Access Compliance Report

Public Rights-of-Way

(Curb Ramps)

Intersection ID: N/A	Main Street: INDEPENDENCE_RD	Cross Street: N/A	Location: E
ADA ID: 65C694CD897A	Ramp Type: Directional1	Initial Pass/Fail: Pass	Overall Compliance: No
		Severity Score: 10

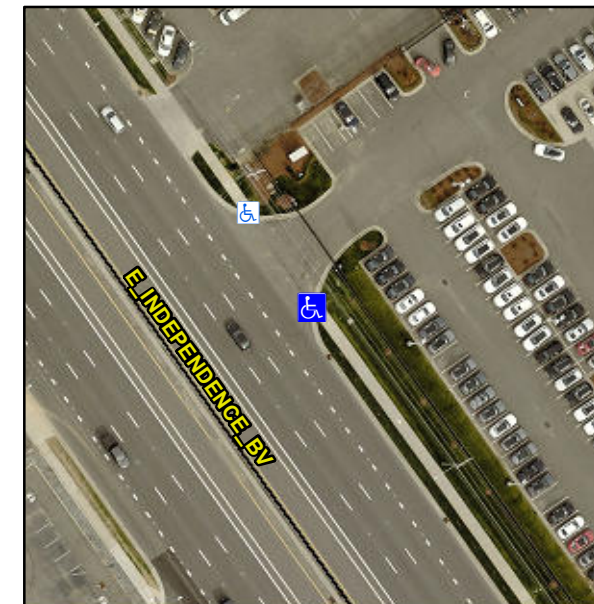
**Not Found, R304.2.2-Perp, R304.3.2-
Para, R304.5.2, R305, R304.5.3**

Compliance	Description	Data	Compliance	Description	Data
N/A	Ramp Length (in)	65.0	No	Grade Break?	No
Yes	Ramp Width (in)	72.0	N/A	Grade Break Slope (%)	3.0
Yes	Ramp Slope (%)	2.9	N/A	Grade Break XSlope (%)	0.9
Yes	Ramp XSlope (%)	1.4			
N/A	Flare Type LT	N/A	N/A	Flare Type RT	N/A
N/A	Flare Slope LT (%)	N/A	N/A	Flare Slope RT (%)	N/A
N/A	Flare Traversable LT?	N/A	N/A	Flare Traversable RT?	N/A
Yes	Landing Length (in)	63.0	No	DWS Provided?	No
Yes	Landing Width (in)	72.0	N/A	DWS Contrast?	No
No	Landing Slope (%)	2.3	N/A	DWS Length (in)	N/A
Yes	Landing X Slope (%)	0.9	N/A	DWS Full Width?	No
N/A	Landing Curb? (Y/N)	N/A	N/A	DWS Offset LT (in)	N/A
N/A	Shared Landing?	No	N/A	DWS Offset RT (in)	N/A
Yes	Gutter Ponding?	No	Yes	Gutter Slope (%)	0.4
Yes	Gutter Lip Ht (in)	0.0	No	Gutter X Slope (%)	2.4
N/A	Painted X Walk1?	No		Road Slope (%)	1.2
	X Walk 1 Direction	To NW		Road X Slope (%)	1.2
	X Walk 1 Width (in)	N/A		Clear Space?	Yes

**Remove & Replace Entire Ramp.
Remove & Replace Gutter.**
